## **Statement of Basis**

G.T.E. Products Corporation

Seneca Falls, Seneca County  
Site No. 850003  
March 2018

Prepared by  
Division of Environmental Remediation  
New York State Department of Environmental Conservation

Note: Figure 3 - Corrective Measures Study Report Addendum October 11, 2016

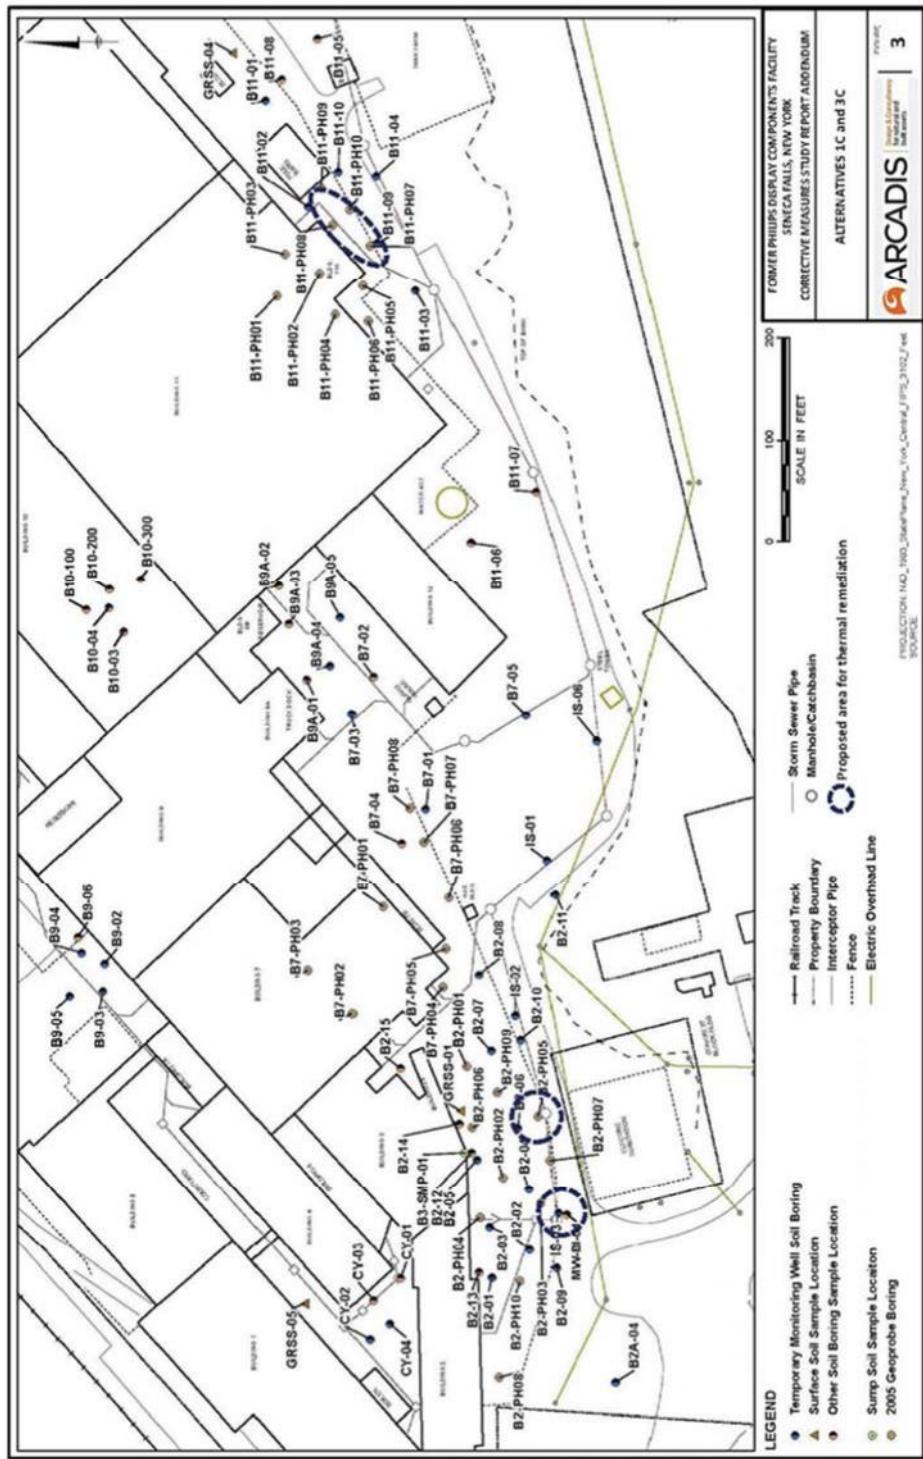
**Comment 10:** The subsection on OU 1, part 3 – In-Situ Thermal Treatment, suggests that electrical resistance heating (ERH) will be the method used to treat soils at the site. This section should be expanded to include a description of thermal conductive heating (TCH), and state that a decision regarding the thermal remediation method (e.g., ERH or TCH) will be made after pre-design engineering data are collected and evaluated.

**Response 10:** The text of the statement of Basis has been amended to reflect the comment.
